SERVICE BULLETIN CHANGE NOTICE

S.B. No. A320-21-1015  
Mod. No. 21224/P01532

TITLE : AIR CONDITIONING - AVIONICS EQUIPMENT VENTILATION - REDUCE  
LEVEL OF VIBRATION AT WALL HEAT EXCHANGER.

SERVICE BULLETIN

Modification of Duct-Blowing in Avionics Compartment  
Figure 1, Sheet 1 of 2

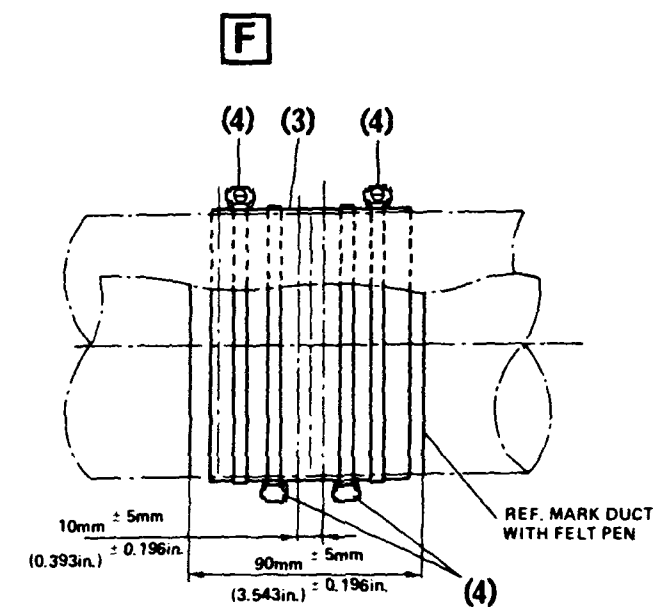
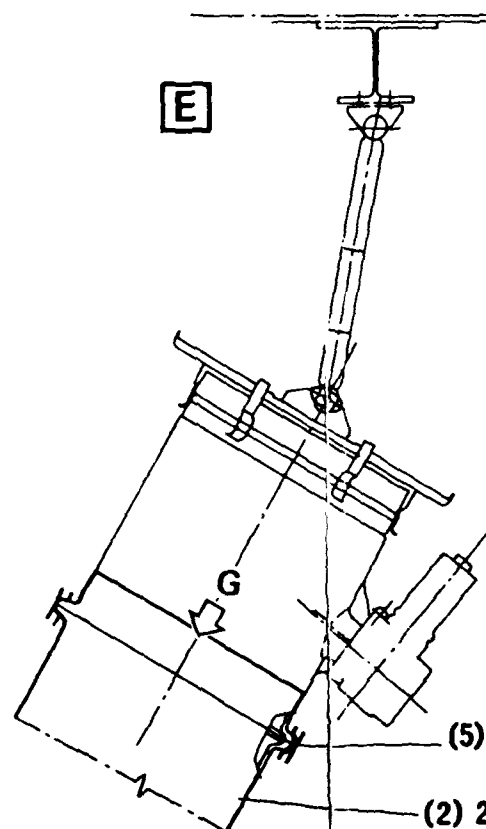
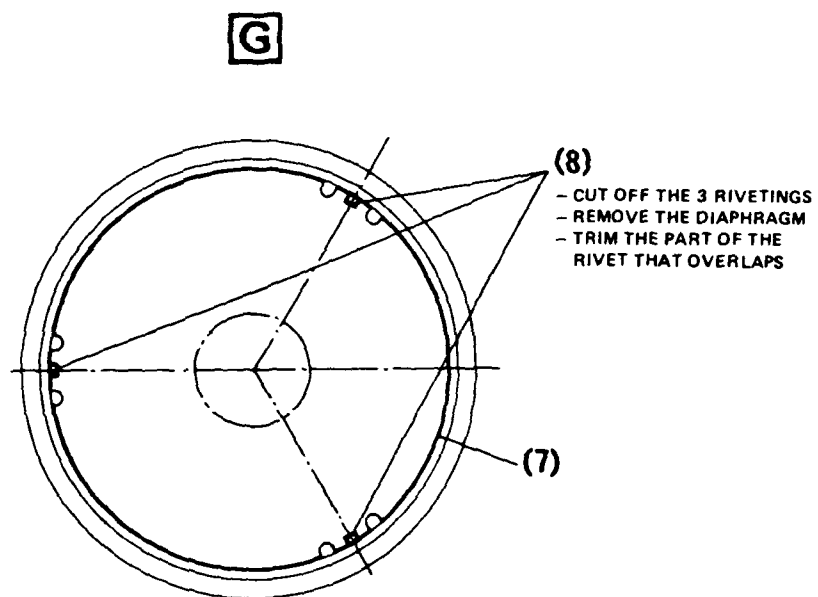
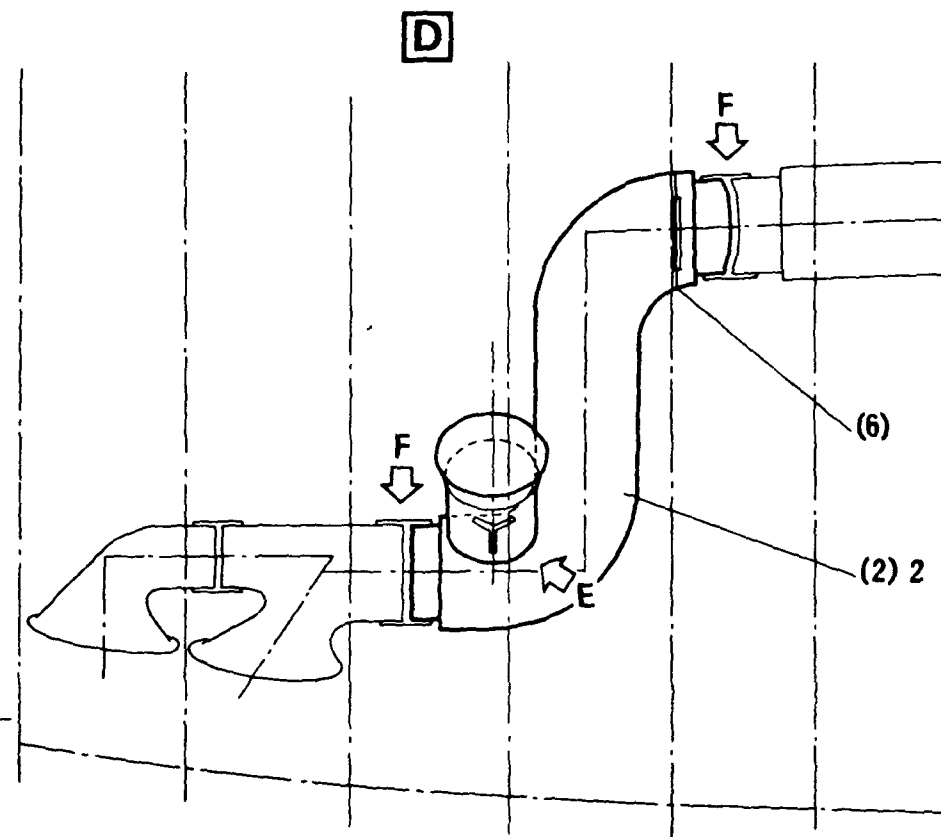
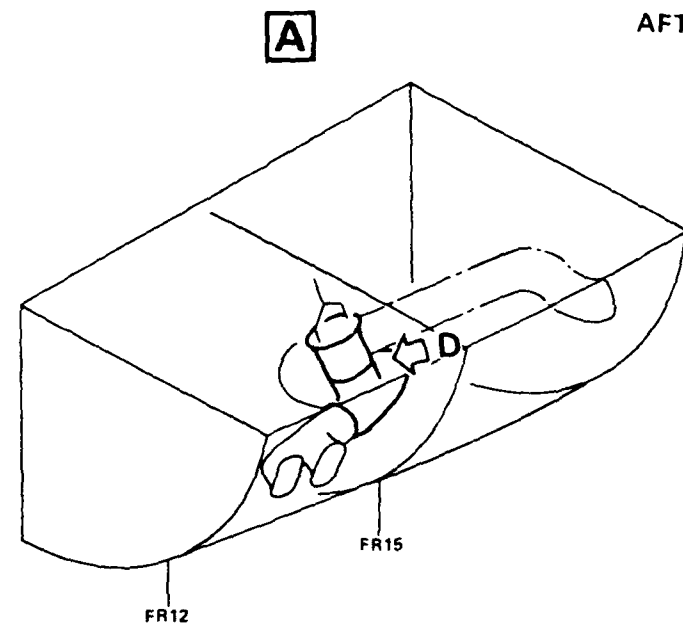
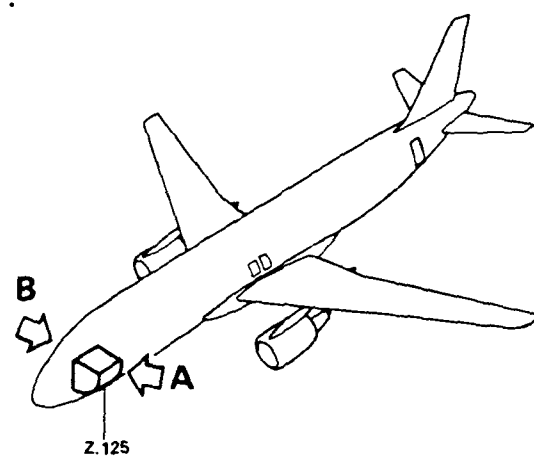
- (2) In avionics compartment, zone 125, modification of blowing duct  
Refer to Figure 1 Sheet 1 of 2

(a) Remove :

1 Blowing Duct	Item (2) (retained)
----------------	---------------------

2 sleeves	Item (3) (retained)
3 Clamps	Item (4) (retained)
1 Clamp	Item (5) (retained)
1 Clamp	Item (6) (retained)

### 3 Rivets

Item (8) (discard)

1 diaphragm

Item (7) (discard)

(e) Identify the modified items :

**02191017900000 becomes 02191017900200**

1 modified Blowing Duct 02191017900200 Item 2

At Shelf 88VU of Electronics Rack 80VU, Replacement of Avionics Equipment  
Ventilation Computer (A.E.V.C.) 10HQ  
Figure 1, Sheet 2

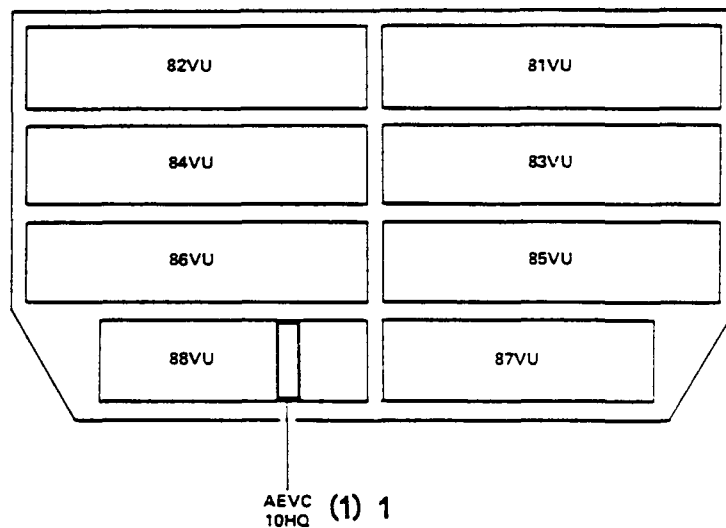
- (1) At shelf 88VU of electronics rack 80VU replacement of Avionics Equipment Ventilation Computer (A.E.V.C.) 10HQ.  
Refer to AMM 21-26-34, P. Block 401

Refer to Figure 1 Sheet 2

(a) Remove :

1 A.E.V.C. (10HQ)	Item (1)
-------------------	----------

(b) Install :

1 A.E.V.C. (10HQ) 87292325V03 Item 1 modified as per instructions of CROUZET Service Bulletin No. 87292325-21-001.
